P 535173

**ON-SITE SEWAGE DISPOSAL SYSTEM
 HOWARD COUNTY HEALTH DEPARTMENT
 BUREAU OF ENVIRONMENTAL HEALTH**

SUBDIVISION: Edgewood Farm LOT NUMBER: 18

ADDRESS: 14620 Corys Court PROPERTY OWNER: Toll MD V LP

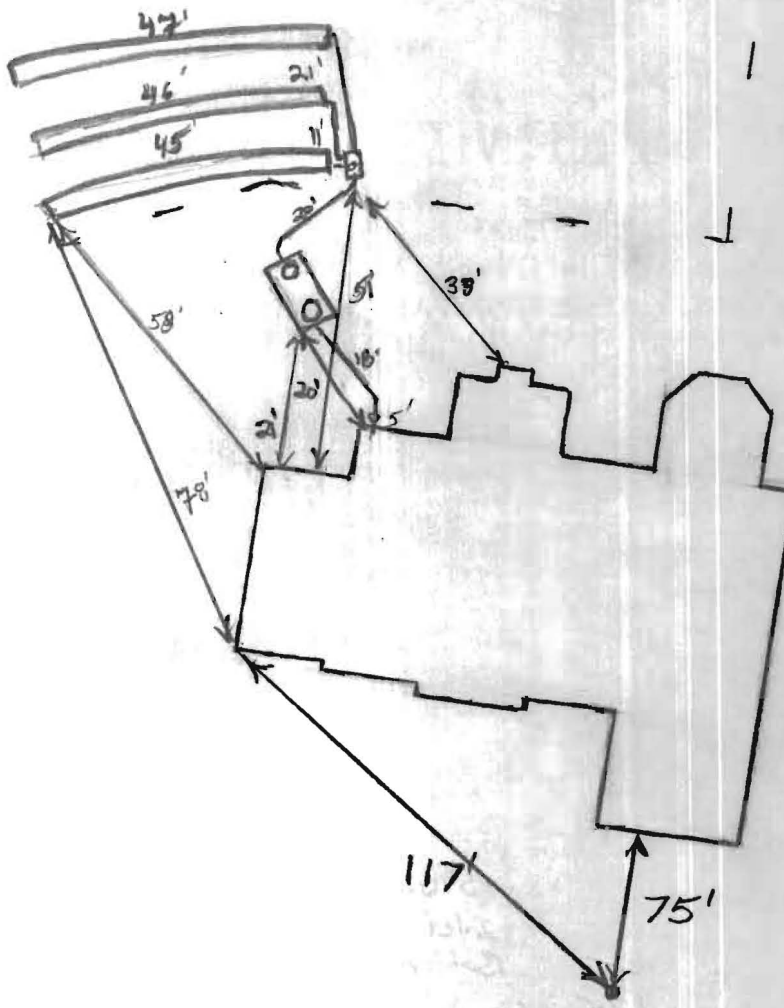
TRENCHES: ^{RB} 2 ^{150'} 135' ^{*Not correct Per records} 7.8 feet
 Trenches to be ~~40~~ feet wide. Inlet 3.0 feet below original grade. Bottom maximum depth 6.0 feet below original grade. Effective area begins at 4.0 feet below original grade with 3.0 feet of stone below distribution pipe.

5/2/2011 Easement not staked. No one at site. (PB)
 5/6/11 Parc Notes do not match. Wrong copy of PL in file. No input given need to revise spec's. 5/9/11 Superintendent enroute homeowner's wanted to construct landscaping around the tank. May have to re-construct Landscaping to adjust for tank location (PB)

5/10/11 Tank set. D box set. Plumbing installed to D box. Top trench inlet 8" deeper than proposed. Field contractor to maintain 3' inlet on all trenches. (PB)
 5/11/11 Trenches complete. D box levelled. OK to backfill (PB)

LOCATION: Set septic tank per layout inspection. Set distribution box at the top center of the easement per layout inspection. Install 3x50' trenches on contour per layout inspection.
